**Alachua County  
Board of County Commissioners  
Staff Report**

**Project Number: DR23-000047**

**Preliminary Development Plan Over Threshold for Newberry Village Traditional Neighborhood Development**

**DESCRIPTION:** Preliminary Development Plan for Newberry Village TND for 639 Residential Units and 224,750 Square Feet of Non-Residential Space

Figure 1 – Left: Sheet C0.33, Right: Sheet C0.20

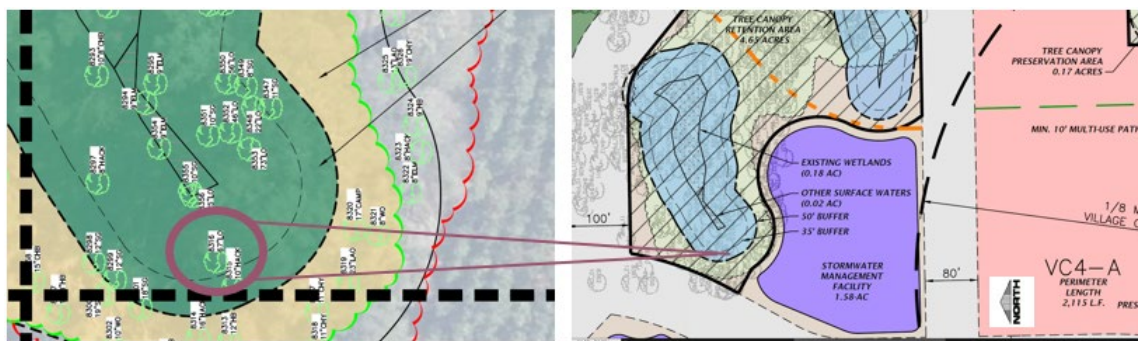
According to Sec. 406.12 *Tree Protection Standards* states, "A tree removal permit for the removal of trees and alteration of associated native vegetation as set forth below may only be issued where the County determines that there are no significant adverse environmental impacts. A tree removal permit authorizing the removal of high quality specimen trees sixty (60) inches dbh or greater may only be issued upon demonstration by the applicant that the development activity cannot occur in any other location on the site, or that removal is unavoidable due to site conditions and design considerations that minimize impacts to other regulated resources." The subject property includes five live oak trees over 60 inches dbh, in average or better condition, that are required to be retained. One is located within the CMA.

Figure 2 – 60" dbh trees in Village Center (Sheet C0.10)

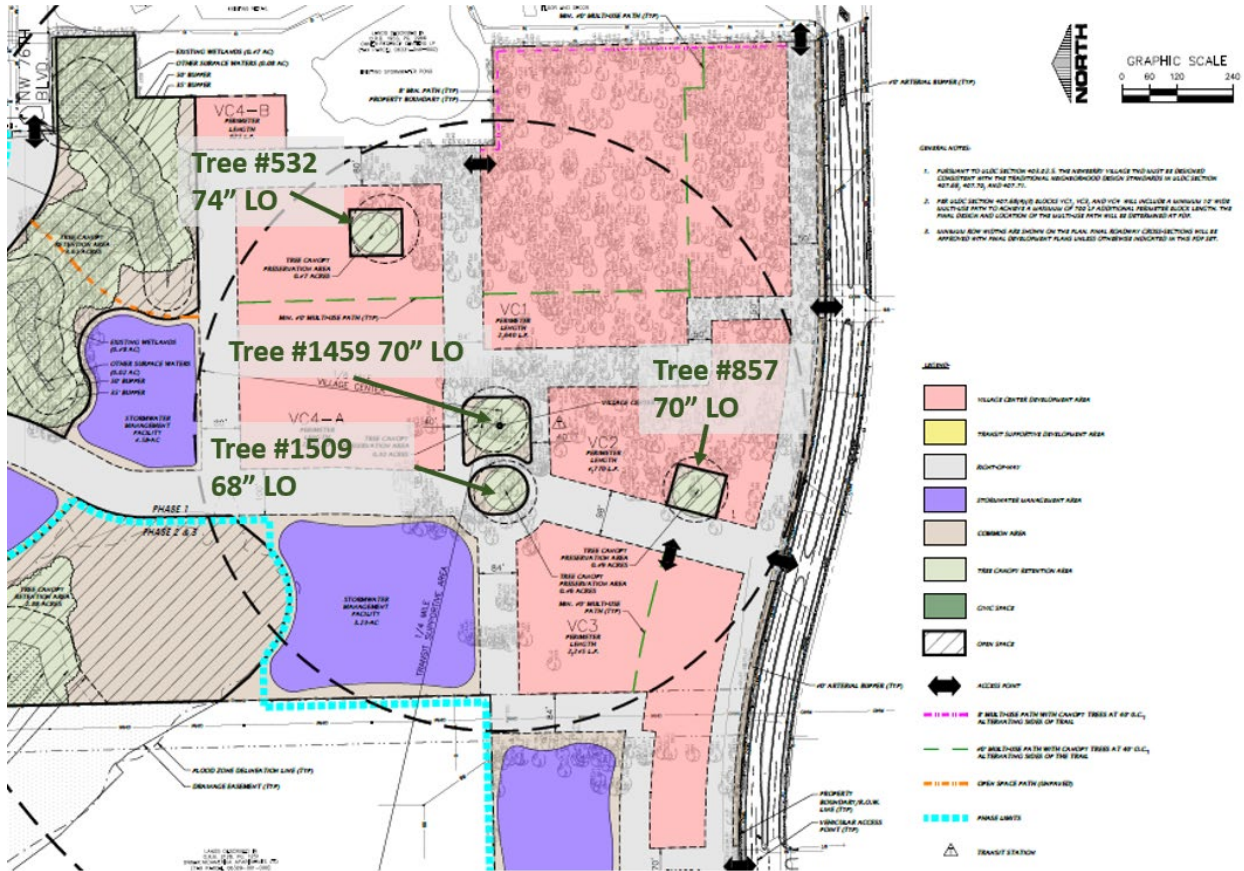
The remaining 4 heritage trees over 60 inches dbh are located within the Village Center. Tree #532, a 74-inch live oak is located within Block VC4-A. Two others – tree #1459, a 70-inch live oak and tree #1509, a 68-inch live oak – are in a proposed dual round-about north of the main entrance to the TND. Tree #1459 is designated as the central point. Tree #857, a 70-inch live oak is in Block VC2. The image below identifies the location of these trees within the Village Center.

The plans currently identify the trees over 60 inches dbh saved to the **dripline only**, instead of the two feet of diameter for every inches dbh outlined in Sec. 406.12.5(c)(1). The following is an outline of the dimensions for protected areas of each tree **if calculated by two feet of diameter for every inch of dbh.**

1. Trees #532 and #1509 must have additional protected areas equal to 2 feet of diameter for every 1 inch of diameter at breast height (dbh). The County may authorize construction impacts to the additional protected areas, per ULDC Section 406.12.5(c)(2). The impacts must not exceed 50% of the additional protected areas. The applicant must identify specific mitigation measures (e.g., mulching, irrigation, and other tree health strategies), as an element of the Final Development Plan, if impacts to the additional protected areas are proposed.

2. Tree #1459 must have an additional protected area equal to 2 feet of diameter for every 1 inch of diameter at breast height (dbh). The County may authorize construction impacts to the additional protected areas, per ULDC Section 406.12.5(c)(2). The impacts must not exceed 50% of the additional protected area. The area of the surveyed dripline that extends beyond the additional protected area is credited toward the maximum allowed impacts of the additional protected area. The applicant must identify specific mitigation measures (e.g. mulching, irrigation, and other tree health strategies), as an element of the Final development Plan, if impacts to the additional protected area are proposed.

Figure 3A

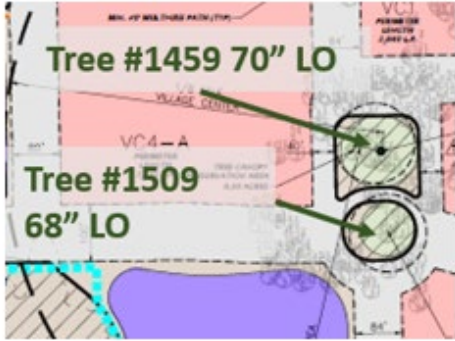
**Tree #532 – 74-inch Live Oak**  
Rated 3.5 - Above average health and vigor for its size. Codominant, bark inclusion, 60% crown density, girdling roots

- Tree #532, 74-inch Live Oak: Protected area circle diameter of 148 feet. This tree has a skewed canopy and thus, following the dripline would not sufficiently protect the critical root zone. Increased root zone protection of the opposite side of the skewed canopy is required.
- Tree #1459, 70-inch Live Oak: Protected area circle diameter of 140 feet
- Tree #1509, 68-inch Live Oak: Protected area circle diameter of 136 feet
- Tree #857, 70-inch Live Oak: Protected area circle diameter of 140 feet. Limited impacts to the west side of the protected area may be allowed due to the location and alignment of the existing right-of-way connection to Newberry Road. Increased root zone protection is required to be undisturbed on the other remaining sides of this tree.

Figure 3B

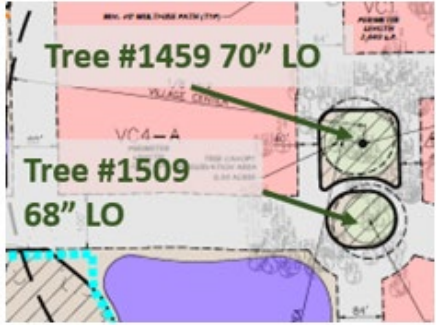
**Tree #1459 – 70-inch Live Oak**  
Rated 3.5 - Above average health and vigor for its size. Codominant trunks, 65% crown density, root flare present.

Tree 1459 has skewed canopy growth and a dripline that extends beyond the southwestern portion of its additional protection area which results in a larger protected area to the west of this tree and staff supports applying the surveyed dripline extension as a part of the 2x additional protected area.

Figure 3C

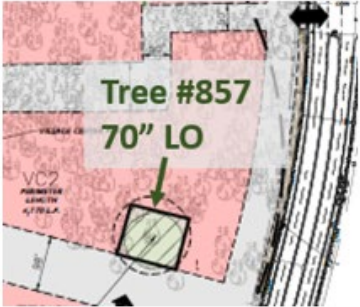
**Tree #1509** – 68-inch Live Oak  
Rated 3.5 - Above average health and vigor for its size. Canopy structure is even, 60% crown density.
